**Planning Department
Transportation Development Services**

Re: Chili's, 1700 Miles Road SE
Traffic Circulation Layout
Engineer's Stamp dated 11-06-14 (M15-D012B)

DRAINAGE AND TRANSPORTATION INFORMATION SHEET

ENGINEER'S SEAL	CHILI'S UNIVERSITY BLVD & GIBSON BLVD	DRAWN BY DY
	SITE PLAN FOR BUILDING PERMIT	DATE 11/05/14
	TERRA WEST, LLC 5571 MIDWAY PARK PLACE NE ALBUQUERQUE, NM 87109 (505) 858-3100 www.tierawestllc.com	2013086-SPE
RONALD R. BOHANNAN P.E. #7868		SHEET # C1
		JOB # 2013086

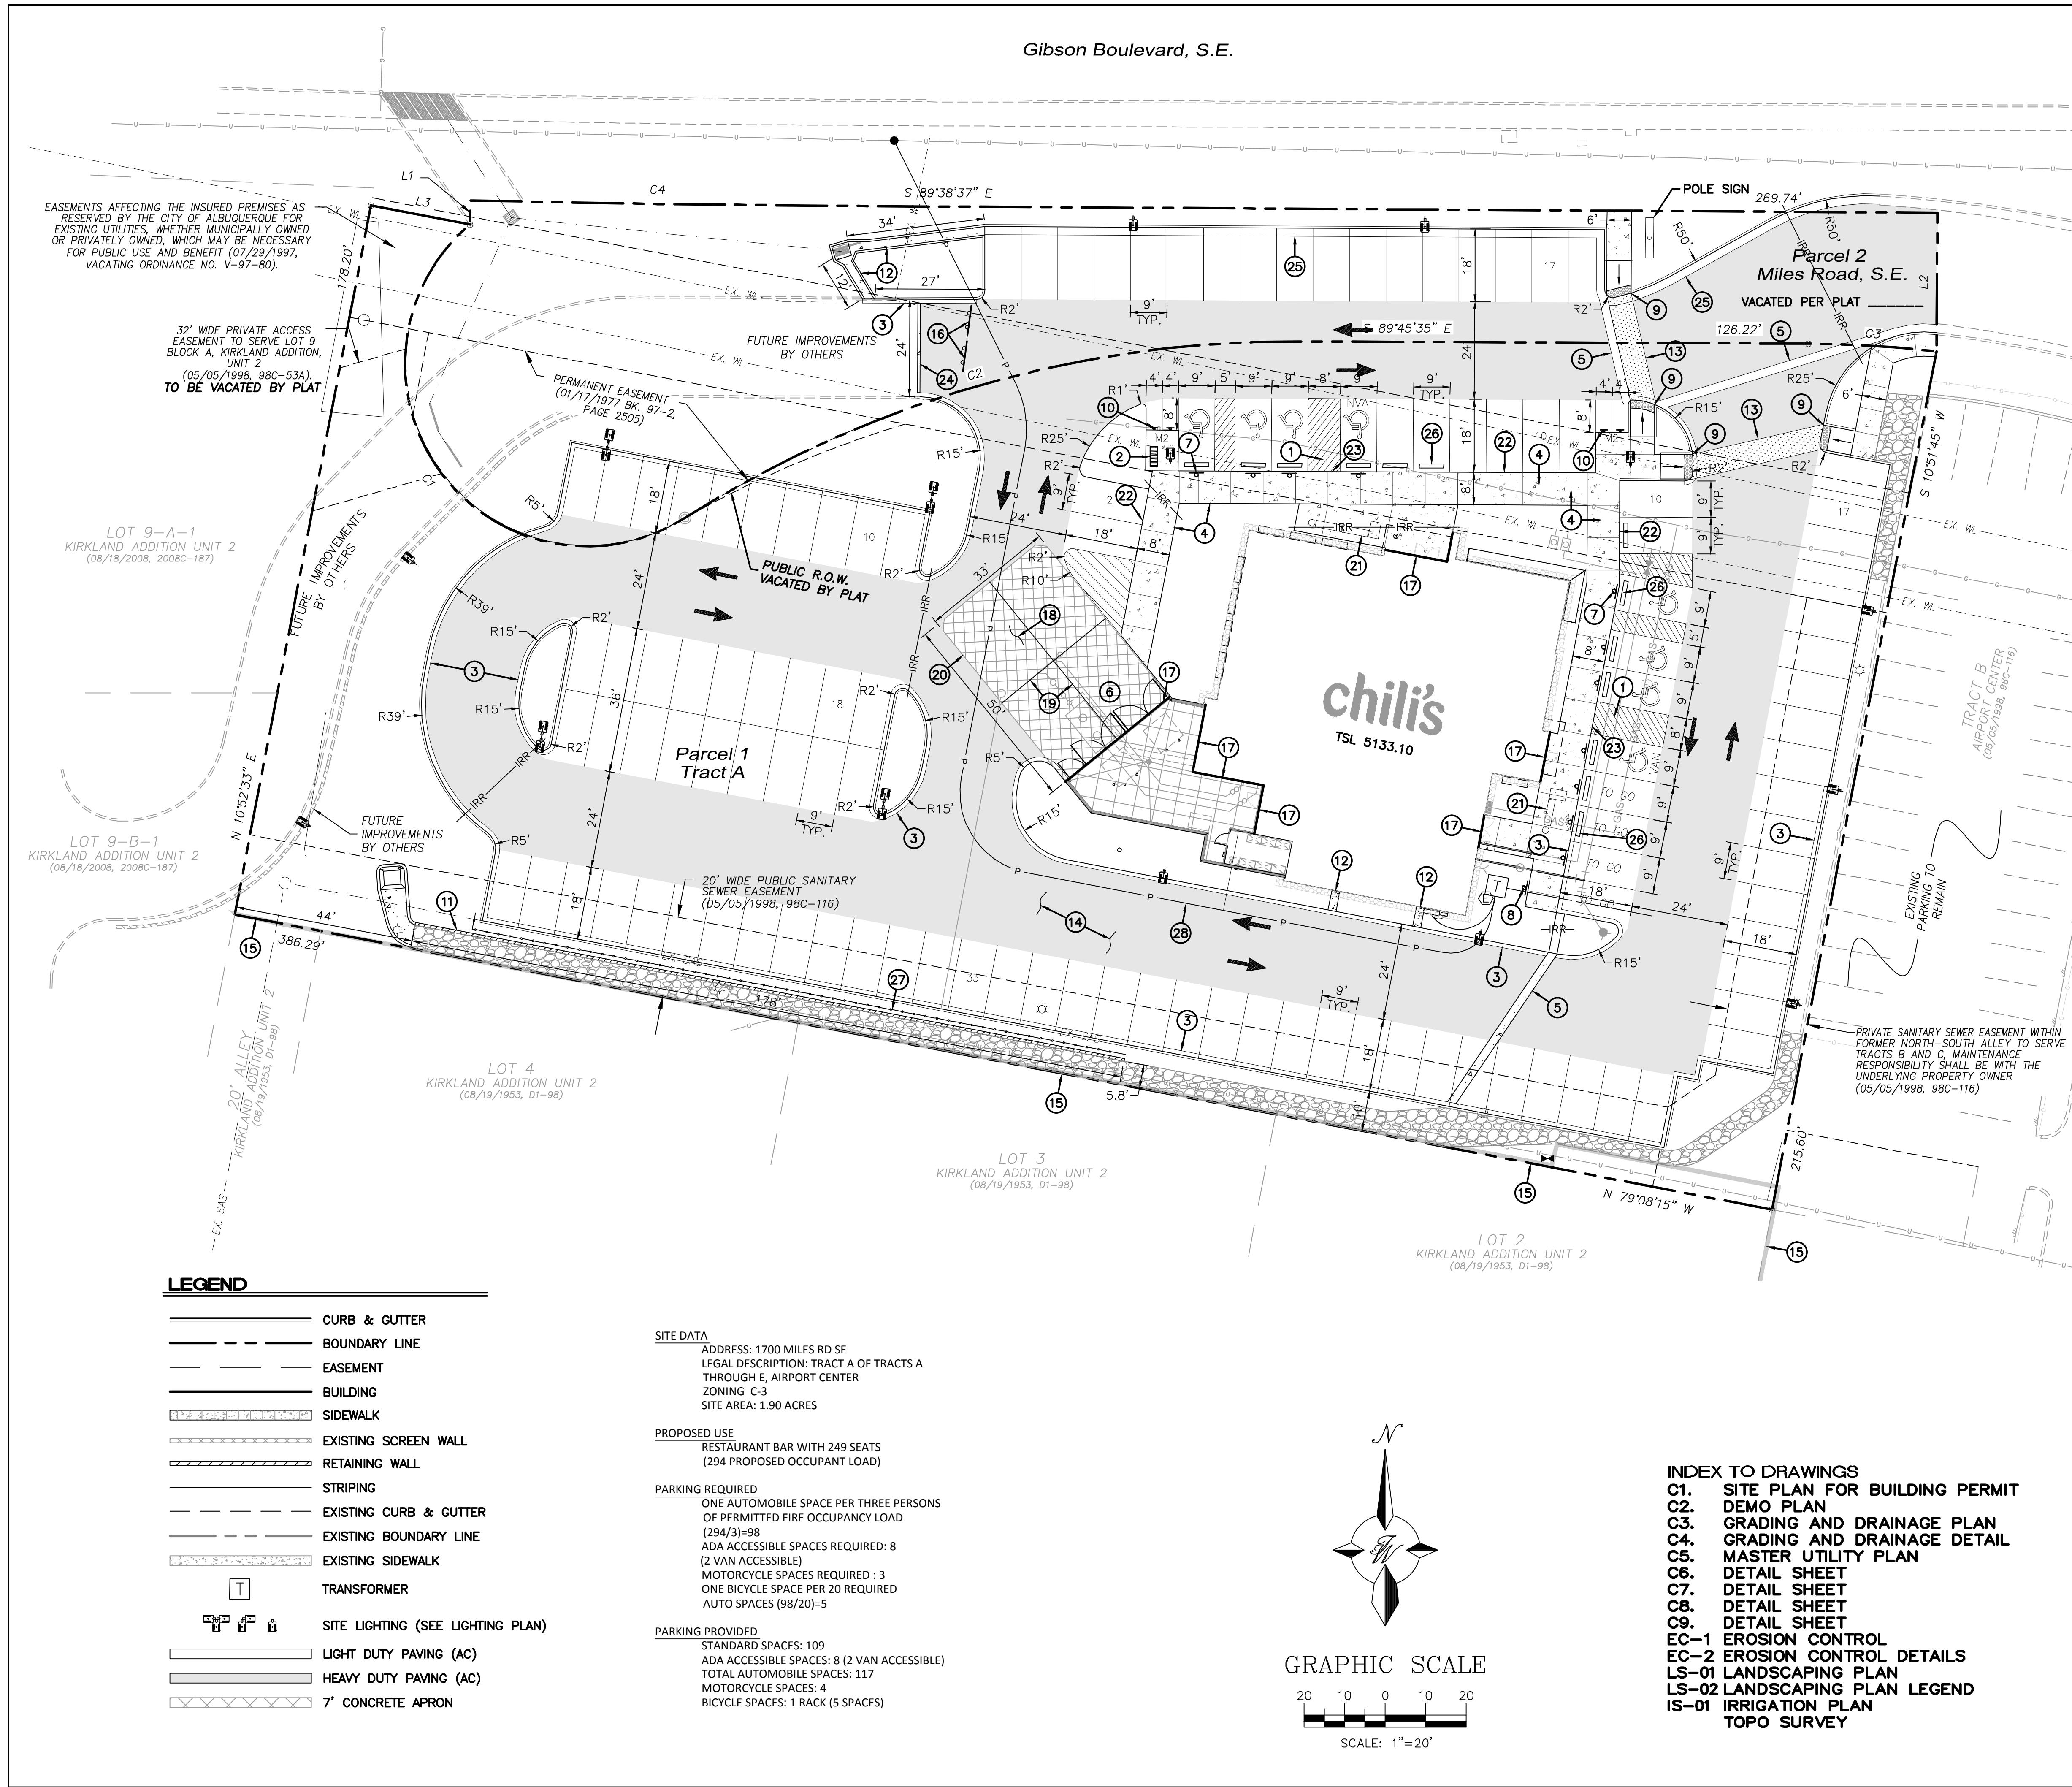
1. Please identify all door entrances to the new building, and list the square footage for the new building.
2. Identify existing pavement, sidewalk, and right-of-way dimensions for Gibson Boulevard. Label and list the dimension for the easement across the site to the north of the new building.

3. Provide Plan Sheets C6 through C8 which show remaining details for signage, curb, and pedestrian ways. The ADA van accessible sign must have the required language per 66-7-352.4C NMSA 1978 "Violators Are Subject to a Fine and/or Towing." There must also be the required language indicating "Van Accessible" per ANSI 502.7.

4. The two 8-foot wide ADA access aisles shall have the words **"NO PARKING"** in capital letters, each of which shall be at least one foot high and at least two inches wide, placed at the rear of the parking space so as to be close to where an adjacent vehicle's rear tire would be placed. (66-1-4.1.B NMSA 1978)

5. Per the DPM, a 6-foot wide ADA accessible pedestrian pathway is required from the public sidewalk to the building entrances. Please extend the 6-foot pathway that you have shown on the plan all of the way to the existing sidewalk on Gibson Boulevard.

6. The design delivery vehicle route needs to be shown. Also, provide a separate sheet showing delivery truck turning movements.

7. Reference the DRB Case Number for the Miles Road vacation, and define limit of the vacation for Miles Road toward the east side of the site. Label the existing Miles Road public road right-of-way and pavement dimensions to the east of the site.
8. Please include two copies of the traffic circulation layout at the next submittal.
